## SERVICE BULLETIN

SUBJECT TS-530S IF UNIT Q2,Q7 PROTECTION

DATE 8-25-83

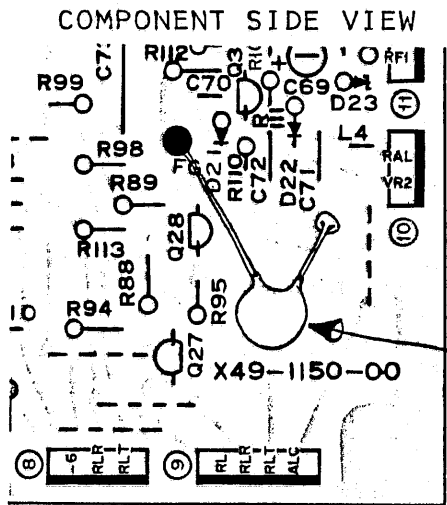
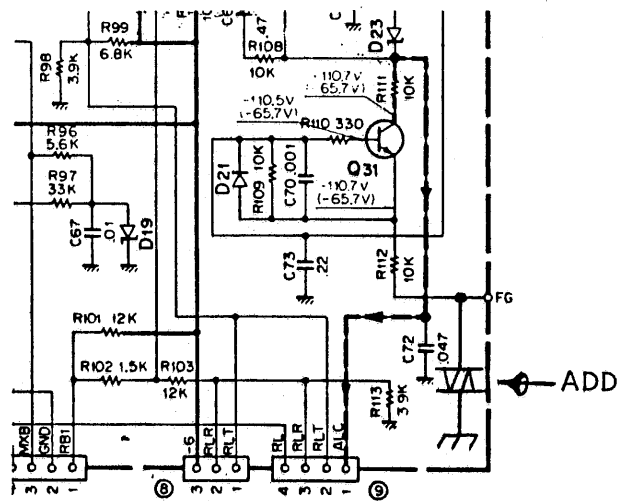
High voltage transients at the receiver antenna can be felt in the ALC circuitry and cause a failure of IF Unit transistors Q2 and Q7. Symptoms encountered may be a loss of RX sensitivity, and or loss of S-Meter deflection.

Add the surge suppressor, as shown in the figures below, to the AF Unit (X49-1150-XX) to prevent a reoccurrence of this symptom.

Parts Required: Surge Suppressor #ERZD03DK331

ADD TO FOIL SIDE OF BOARD
